Ref: 17194-ASC-Z8-BCAReport-230420

ARMIDALE SECONDARY COLLEGE

**BUILDING CODE OF AUSTRALIA 2016 AMENDMENT 1
ZONE 8 REDESIGN & WALKWAYS TO DEN & BUS STOP**

APRIL 2020

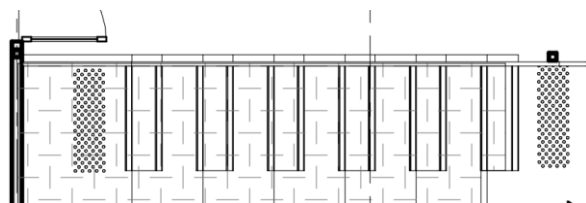
The space below a required non fire-isolated stairway (to the tiered seminar space) must not be enclosed to form a cupboard or other enclosed space unless the enclosing walls and ceilings have an FRL of not less than 60/60/60 and any access doorway to the enclosed space is fitted with a self-closing –/60/30 fire door.

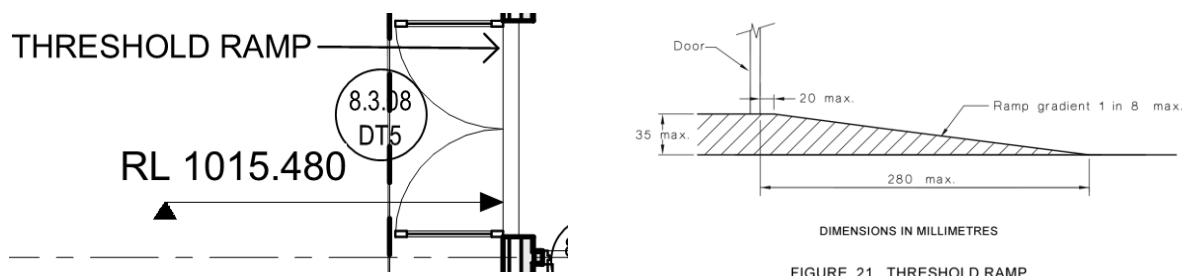
Please note that threshold ramps are not permitted to be under the doors and are to start at the doorway or a maximum distance of 20mm from the edge of the doorways.

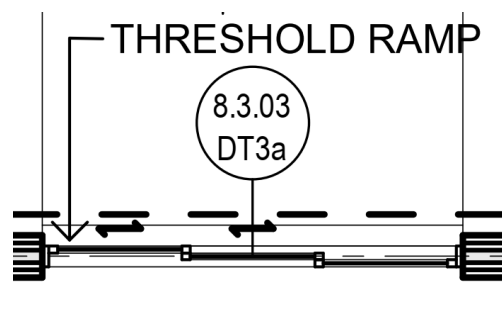
The sliding door shown below is required to be automated or provided with a compliant D pull handle that has a minimum 60mm gap between it and the door frames when in the open and closed position.

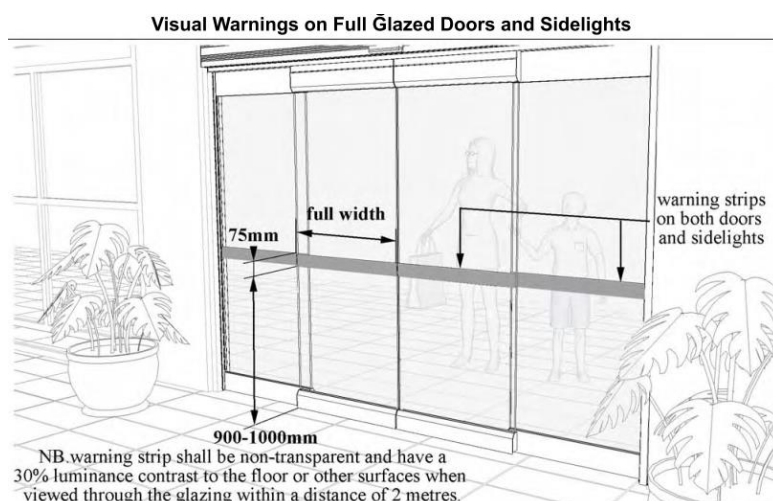
The tiered seminar seating is deemed to be fixed seating in a Class 9b building and are required to be provided with wheelchair seating spaces as per the BCA and AS1428.1 2009.

This has been addressed in a performance solution.
